Date: **March 5, 2001**

Model: **BVM-D20F1E, BVM-D20F1U**
BVM-D24E1WE, BVM-D24E1WU

Subject: **CORRECTING INTERMITTENT**
FLUCTUATION OF VERTICAL LINEARITY

Figure 1

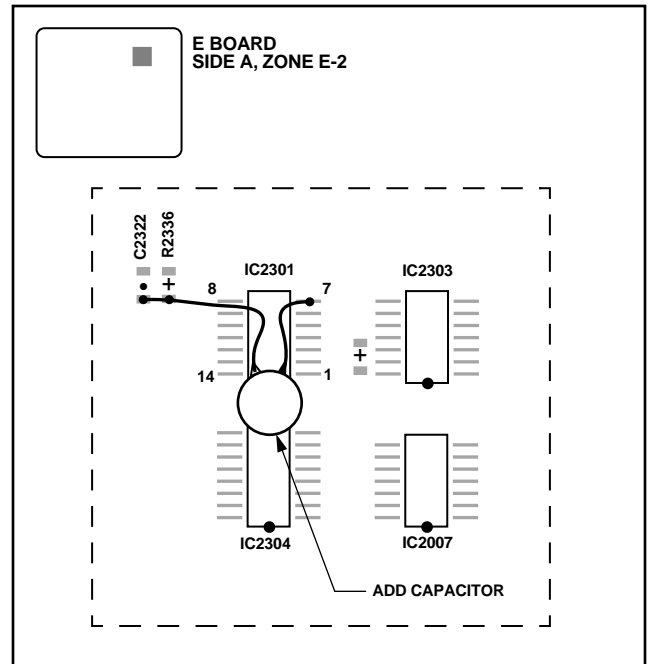
Vertical linearity may fluctuate intermittently when unit is operated in a low temperature environment. To correct this condition, perform the following modification procedure.

E Board (Side A, Zone E-2)

1. Bend the leads of the capacitor as shown in Figure 1.
2. Solder one lead of the capacitor to IC2301 pin 7.
3. Solder the other lead of the capacitor to C2322 and R2336.
4. Affix the capacitor to the board with RTV.
